LOUISIANA
POWER & LIGHT

SUBJECT: Waterford SES 3
Docket No. 50-382
Formal submittal of follow up items from SQRT audit

RESPONSE TO SORT ADIT

RESPONSE TO CE/PLANT ENGINEERING
CONFIRMATORY ITEMS FROM WATERFORD UNIT #3
SQRT RE-AUDIT

LOUISIANA POWER & LIGHT CO.
BATERFORD S.E. 3. UNIT NO. 3
CONTROL WIRING DIAGRAM

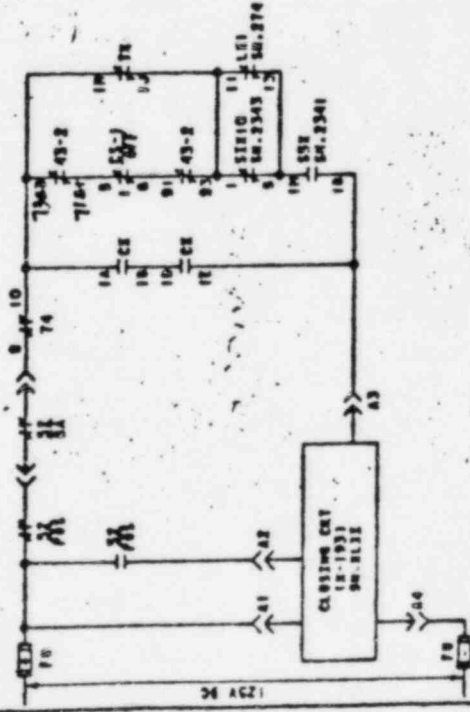
Please refer to the attached Control Wiring Diagram Dwg No. LOU 1564B-424, Sheet E365.

Furthermore, we have suggested that the wiring of the tripping contact 2-2 be modified to connect contact 2-2 in series with N.O. of SIS relay, this will prevent 2-2 from tripping the charging pump during the emergency operation, at the same time we will not suspend the protective function of the lube oil pressure switch. The existing lube oil pressure low alarm remains active during normal and emergency operation of the charging pump.
